<b>Docket Number:</b>	16-AFC-01
<b>Project Title:</b>	Stanton Energy Reliability Center
<b>TN #:</b>	224777
<b>Document Title:</b>	SERC Revised Natural Gas Figures and Declaration of Doug Davy
<b>Description:</b>	N/A
<b>Filer:</b>	Scott Galati
<b>Organization:</b>	DayZenLLC
<b>Submitter Role:</b>	Applicant Consultant
<b>Submission Date:</b>	9/23/2018 9:42:32 AM
<b>Docketed Date:</b>	9/24/2018

**Subject: Stanton Energy Reliability Center (16-AFC-01)  
Second Resubmission of Maps to Conform to Evidence (Reference TN #224652)**

**Figure 1.3-1**  
**Project Location**  
 Stanton Energy Reliability Center AFC  
 Stanton, California

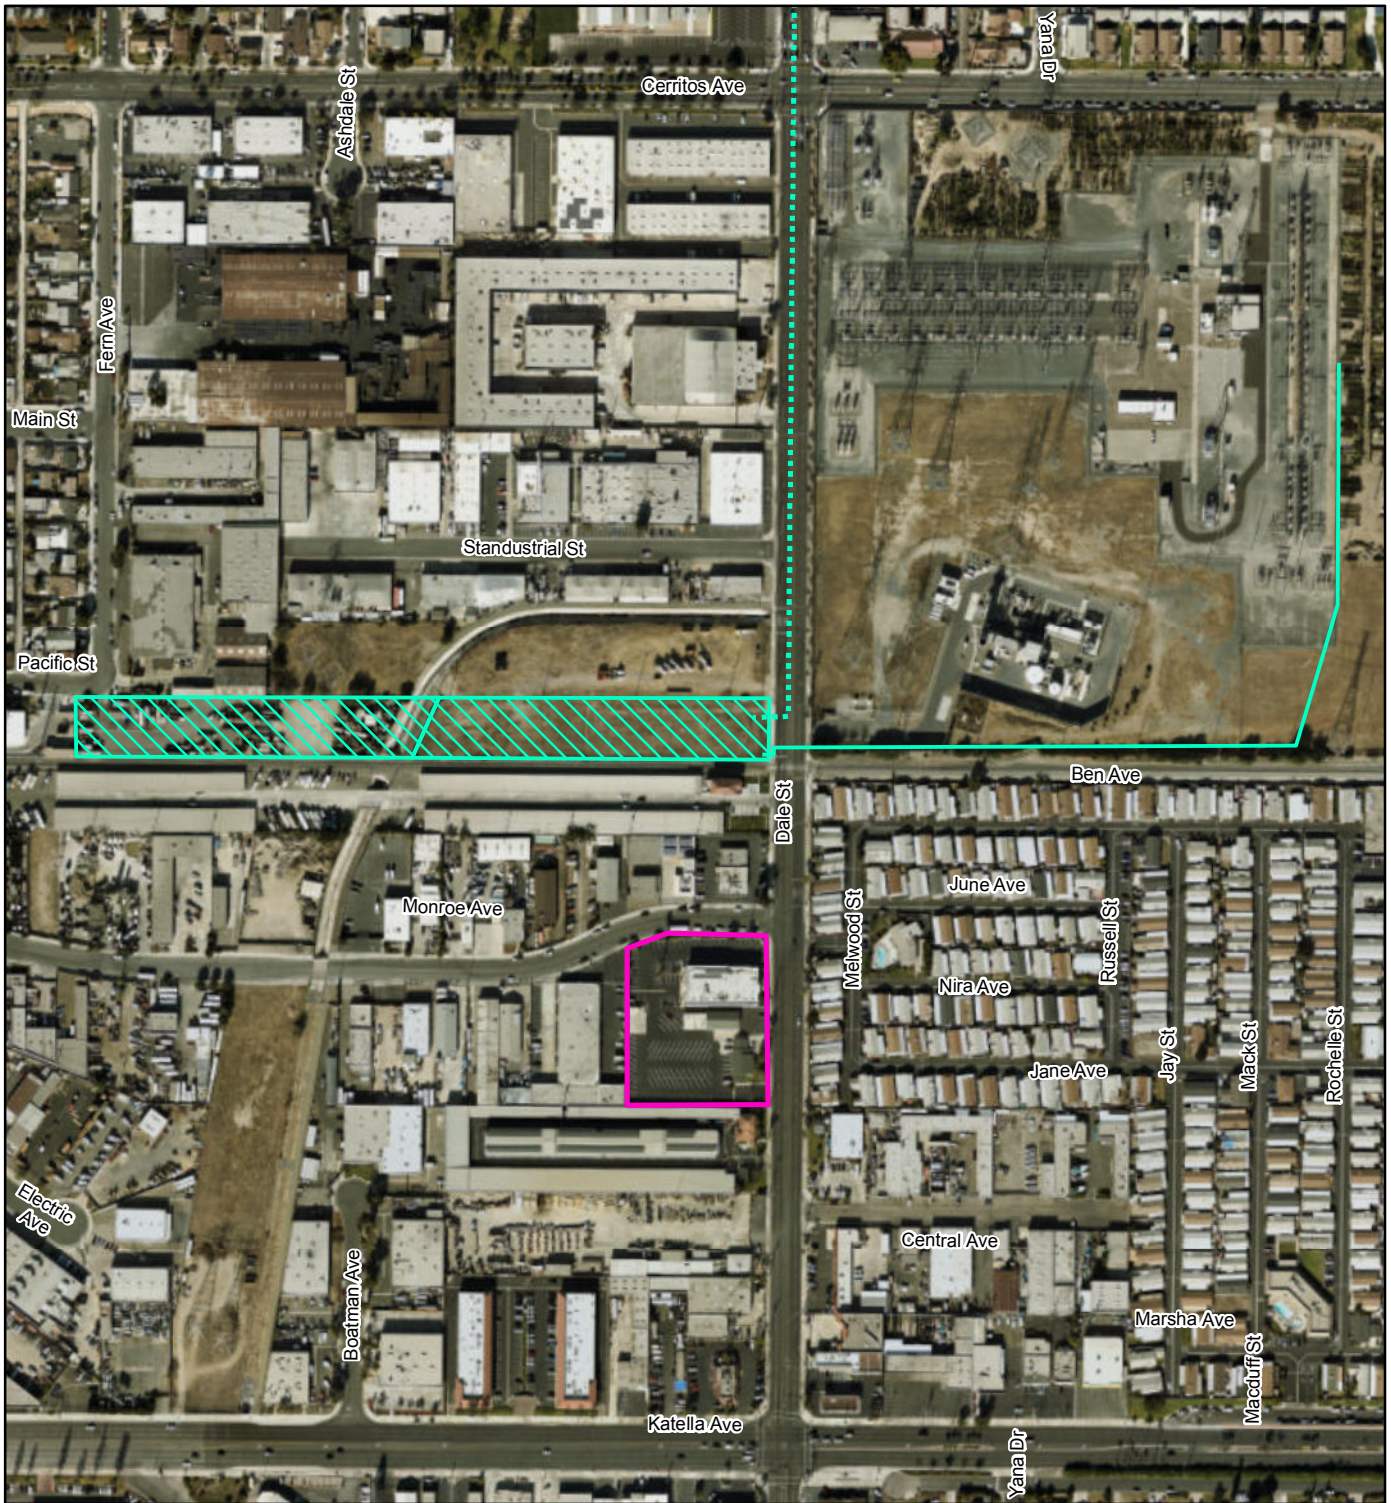
We have revised the following figures to remove from within the Site Boundary an area that Southern California Gas Company may use for a staging area (Staging Area A) during construction of the natural gas pipeline. This is not part of the Project Site and therefore should not be included within the Site Boundary. These revisions supersede the those docketed on September 14, 2018 (TN 224723) to these same figures:

- Exhibit 6, page 1-9 (Figure 1.3-1, Project Location)
- Exhibit 7, page 2-29 (Figure 2.1-5, Construction Worker Parking Area)
- Exhibit 17, page 5.7-5 (Figure 5.7-1, Sound Monitoring Locations)

3. I caused to be prepared three of the nine revised Figures as directed by the Committee in its Order dated September 5, 2018 (TN 224652) for the Stanton Energy Reliability Center (16-AFC-01). The original figures were revised to remove the southern gas line route as directed by the Order. The revised Figures are attached and are:
